**IOWA DEPARTMENT OF TRANSPORTATION**

**TO OFFICE:** District 1                                 **DATE:** May 23, 2013  
**ATTENTION:** Scott Dockstader                         **REF. :** Marshall County  
**FROM:** Kevin K. Patel   BRFN-96-1(6)--39-64  
**OFFICE:** Design   PIN: 11-64-096-010  
**SUBJECT:** Field Exam

A field exam was held on Tuesday, May 14, 2013, to review the proposed plan for replacing a bridge over Devil's Run Creek on IA 96, approximately 1.8 miles east of County Road T-29.

**MARSHALL CO.** RCB Culvert New - Twin Box BRFN-096-1(6)--39-64 LETTING DATE 2/17/2015

**FILL FOR CULVERT USED  
IN BRIDGE REPLACEMENTS**

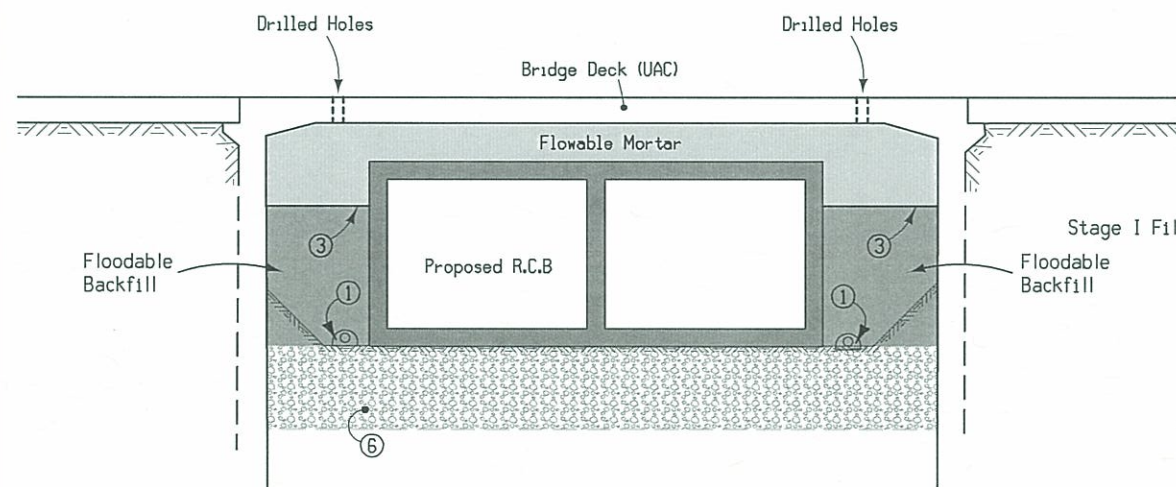
*show plan view  
of flowable mortar  
holes*

### TRAFFIC CONTROL PLAN

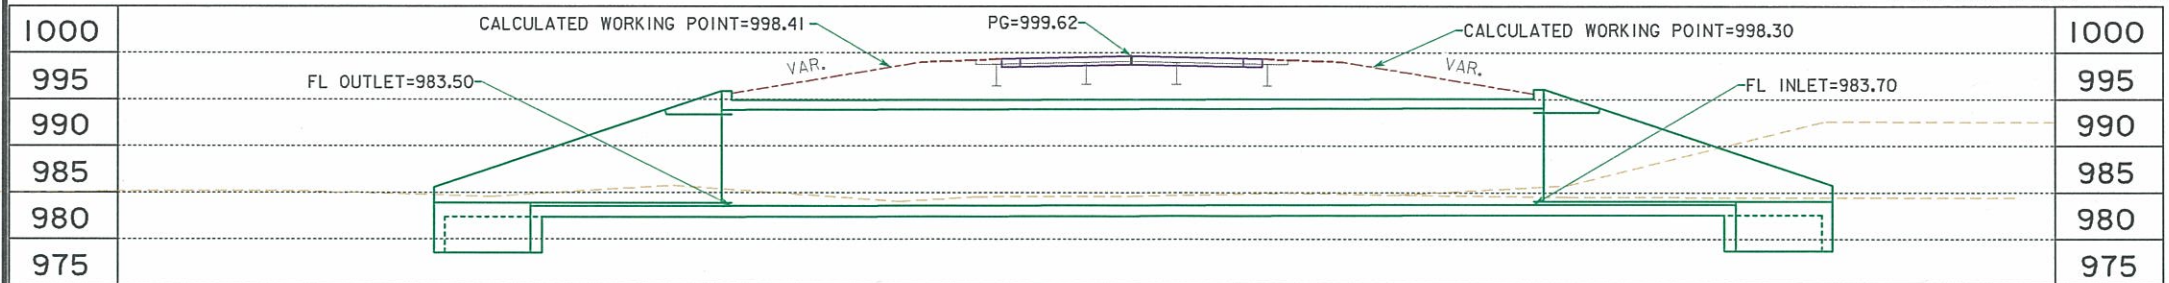
4. Place temp traffic signal, place patches, remove bridge rail

Will need flaggers for drilling holes in deck & pumping Flowable mortar

SITUATION PLAN

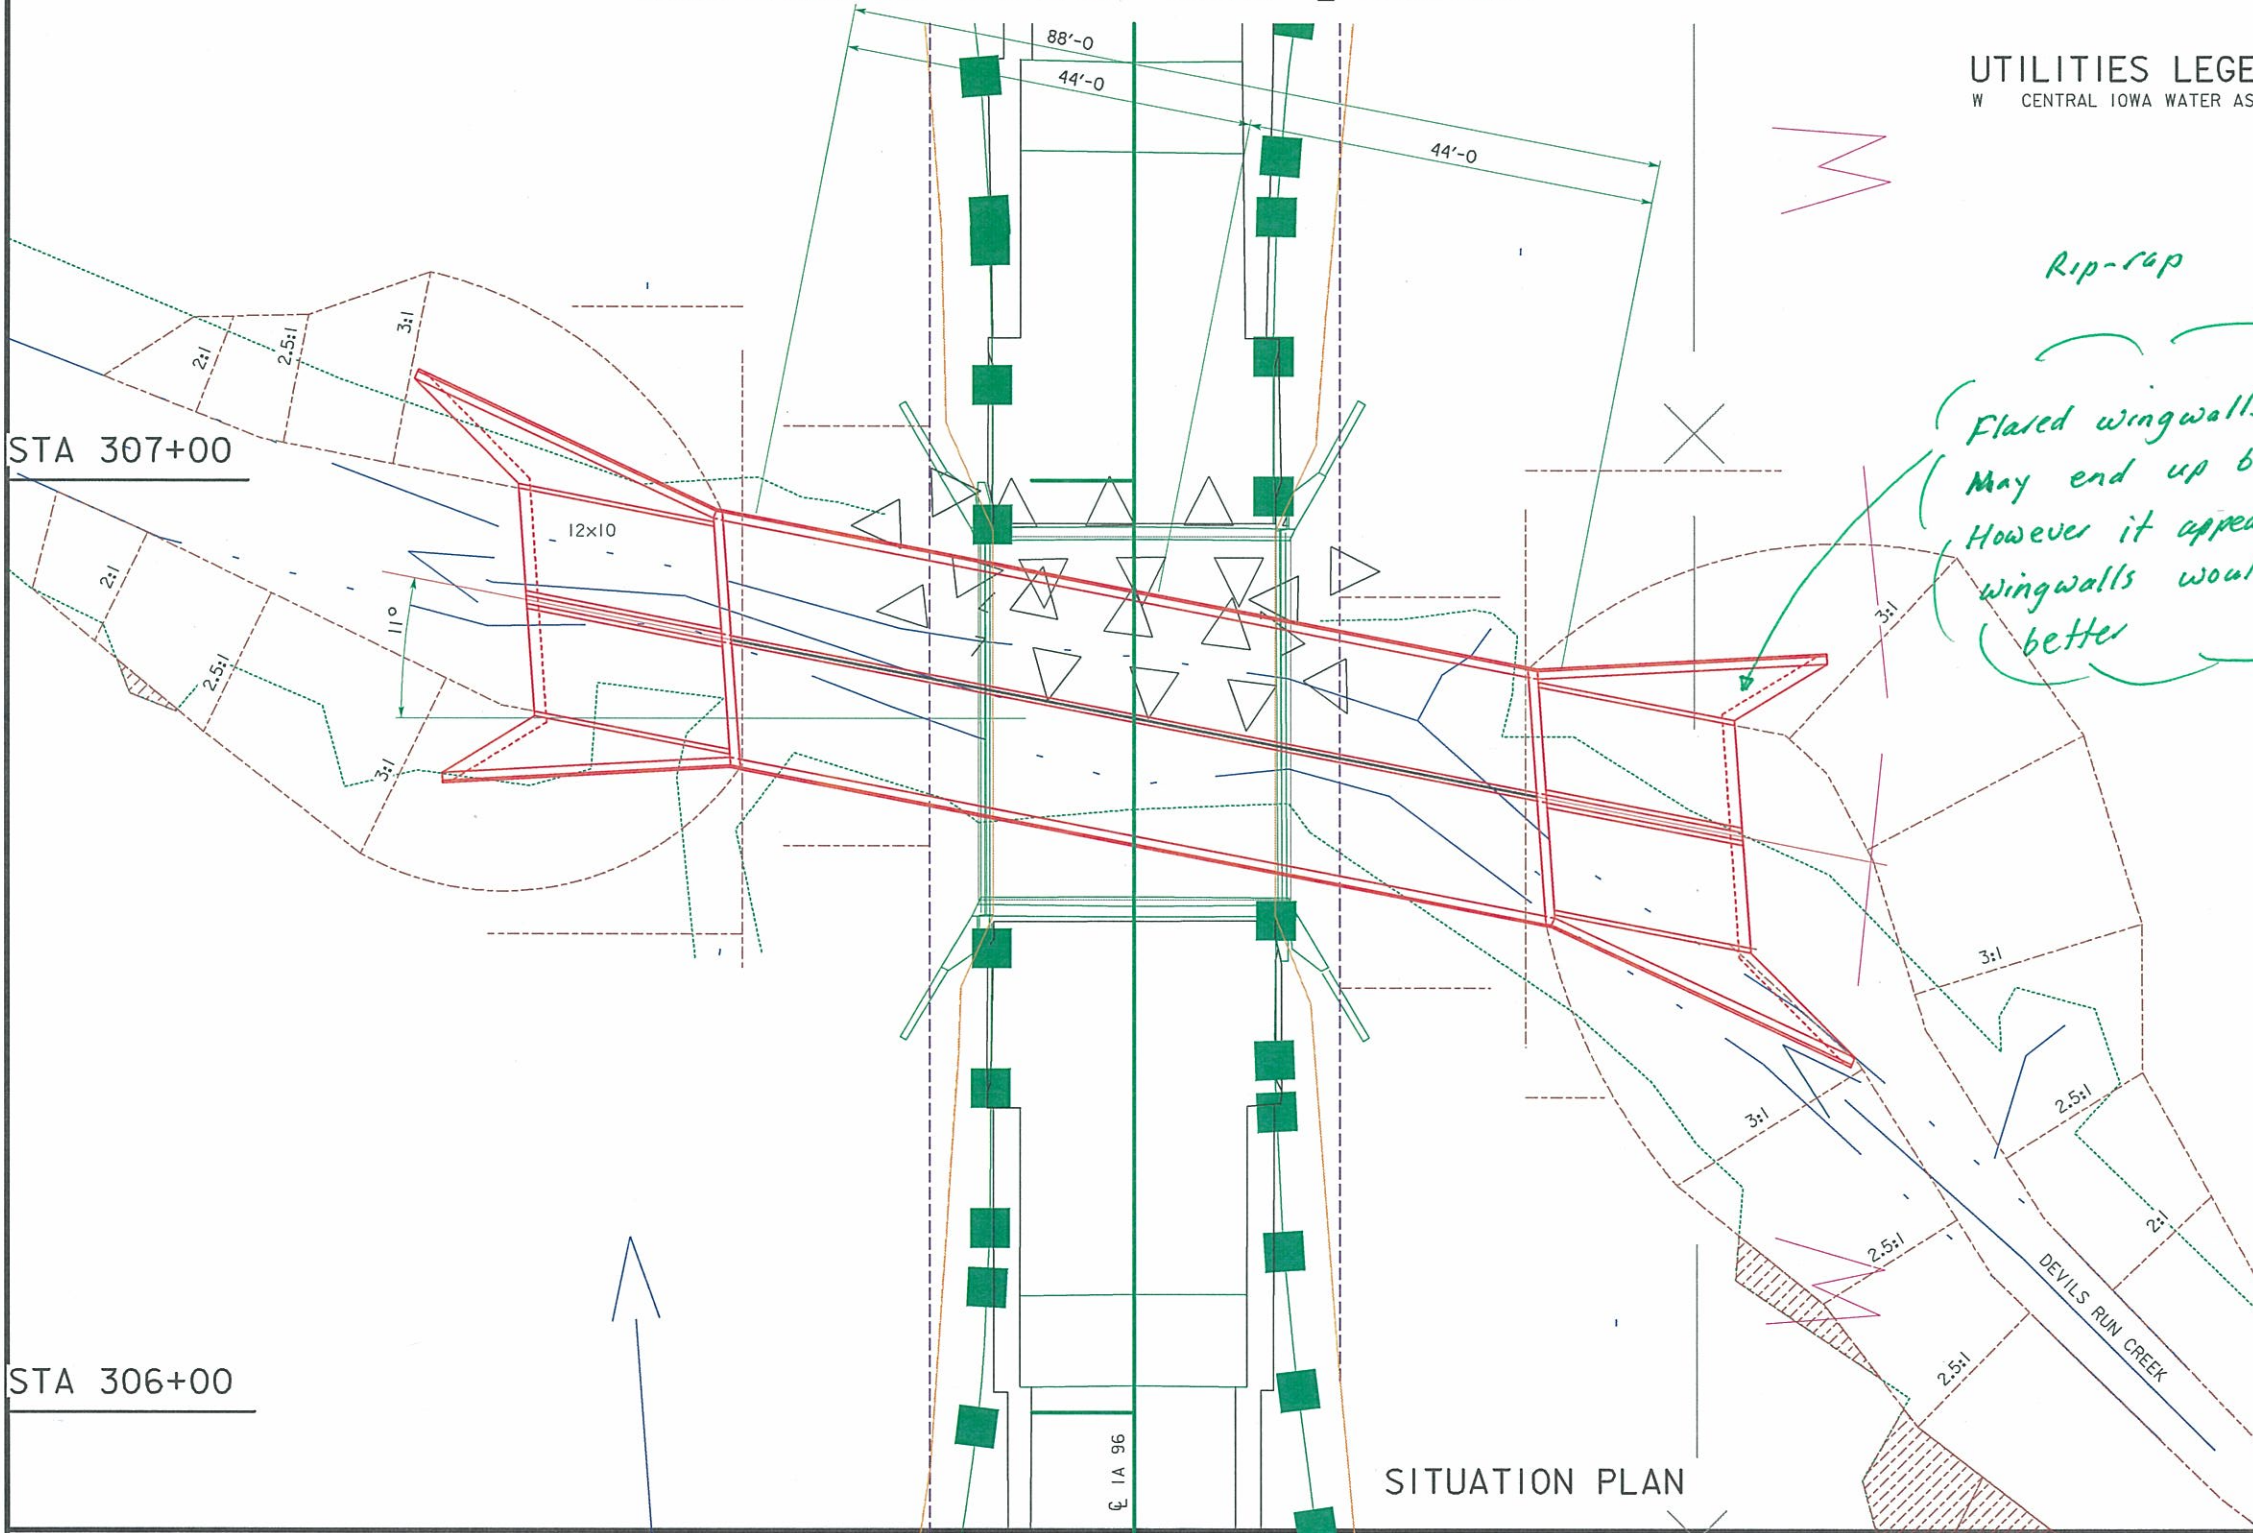
*Rip-rap*

*(Flared wingwalls shown  
May end up being parallel?  
However it appears flared  
wingwalls would fit  
better)*

*No flood plain  
permit < 100 sq  
mile rural area*
